Questions and Answers # 1

Offeror Questions

<table><tr> <td colspan="2"><u>CALCULATION</u> (From sheet A111)</td> </tr></table>

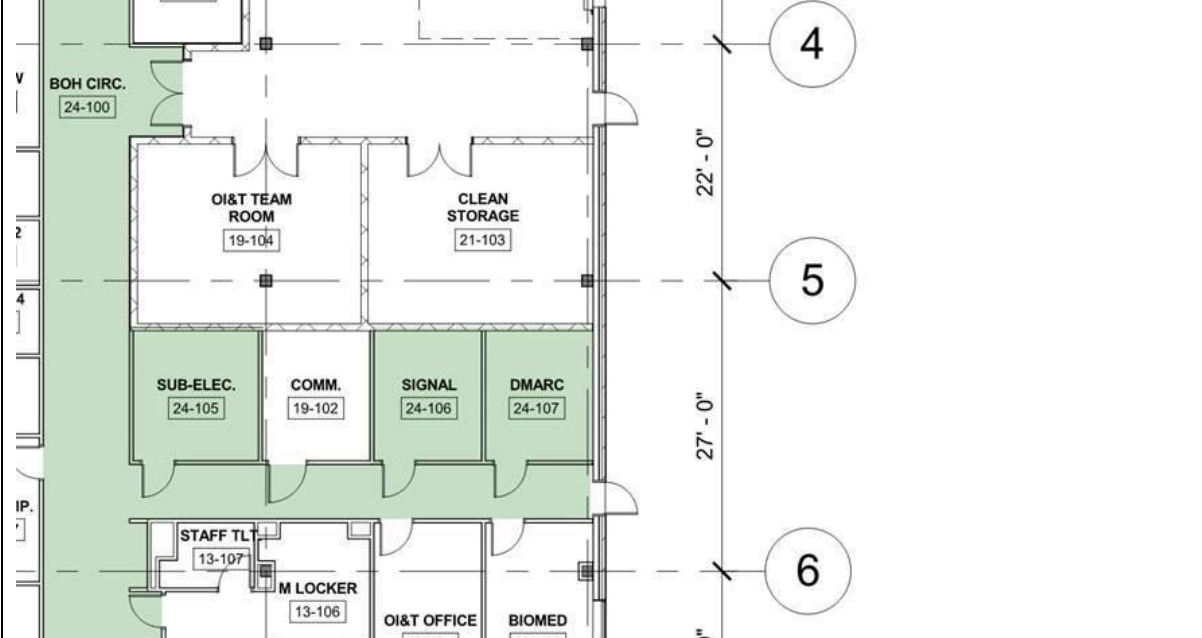
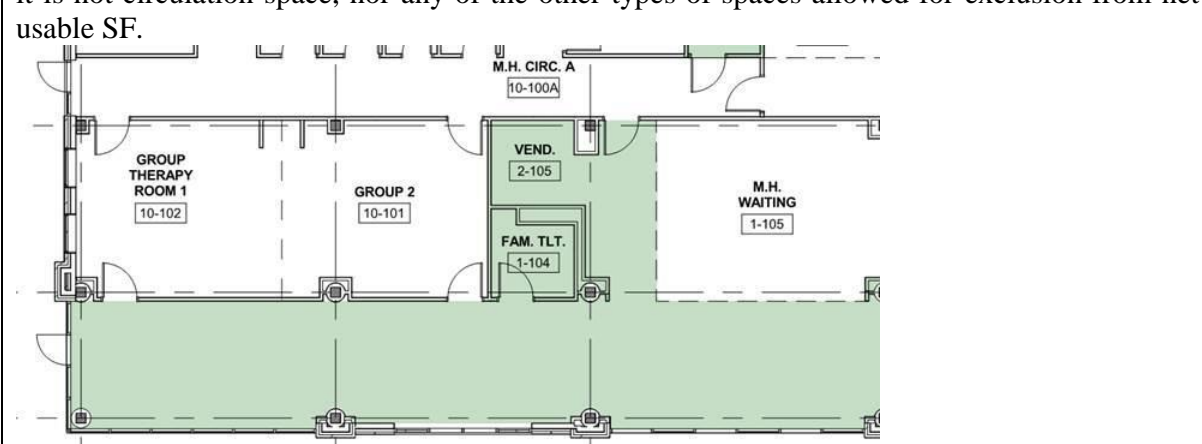
b.	<p>Should Vending 2-105 at the west end of the building be considered part of the net usable SF? Should it be colored green in plan and not part of the green hatch? Though open to the corridor, it is not circulation space, nor any of the other types of spaces allowed for exclusion from net usable SF.</p>

Answer:	<p>No, vending shall remain within Hatch Deduct area.</p>
c.	<p>In both of the snips above, the walls along the circulation corridor are not part of the green colored hatch. Should the corridor walls be included as part of the excluded SF? In Section 3.14.2 of the SFO, it states to “Deduct the following from the inside gross area including their enclosing walls to arrive at the figure for net usable square feet.” It then lists the excluded types of spaces. It would seem, then, that the corridor walls (since they enclose the corridor) should be part of the excluded SF.</p>

Question	
Answer:	<p>Both Comm. Rooms (19-102 and 19-103) shall be included in Hatch Deduct. Hatch Deduct increase (sheet A111) of 243 sf = total 14,276 sf.</p>

Question
	Answer: Walls enclose the tenant space, not the corridor. Corridor walls are excluded in 3.14.2 only if on a multiple tenancy floor.
11.	<p>Again in Section 3.14.2 of the SFO, it lists a ratio of 78% to 22% of inside gross area vs. area excluded for corridors and circulation. 22% of 63,737 = 14,022, which is close to the listed excluded SF of 14,033. However, the SFO says “corridors and circulation”. The excluded SF is not just corridors and circulation. It also includes mechanical space, HACs, etc. Can we get clarification on this 78% / 22% ratio? And does this ratio need to be maintained if the floor plan were to change?</p> <p>3.14.2 NET USABLE SPACE</p> <p>Net usable space is that portion of rentable space that is available for a tenant's personnel, furnishings, and equipment. Net usable space is the area for which VA will pay a square foot rate. It is determined as follows:</p> <ul style="list-style-type: none"> • If the space is on a single tenancy floor, compute the inside gross area by measuring between the inside finish of the permanent exterior building walls or from the face of the convectors (pipes or other wall-hung fixtures) if the convector occupies at least 50 percent of the length of exterior walls. • If the space is on a multiple tenancy floor, measure from the exterior building walls as above and to the room side finish of the fixed corridor and shaft walls and/or the center of tenant-separating partitions. <p>In all measurements, make no deductions for columns and projections enclosing the structural elements of the building. Deduct the following from the inside gross area including their enclosing walls to arrive at the figure for net usable square feet:</p> <ul style="list-style-type: none"> • 78% of the inside gross area is considered net usable space per drawing sheet A111. Refer to paragraph 4.2.3 for specific information. • 22% of inside gross area for corridors and circulation (Refer to sheet A111 for square footage calculations). • Public toilets and public lounges. See Paragraph 4.2.3. • Building equipment and service areas. • Entrance lobbies. • Stacks and shafts.

<p>Answer: This ratio will change based on future floor plan revisions.</p> <p>Revision based on increase of Hatch Deduct indicated in Question 10.b response: $14,276 / 63,737 = 22\%$; $100\% - 22\% = 78\%$ NUSF</p>
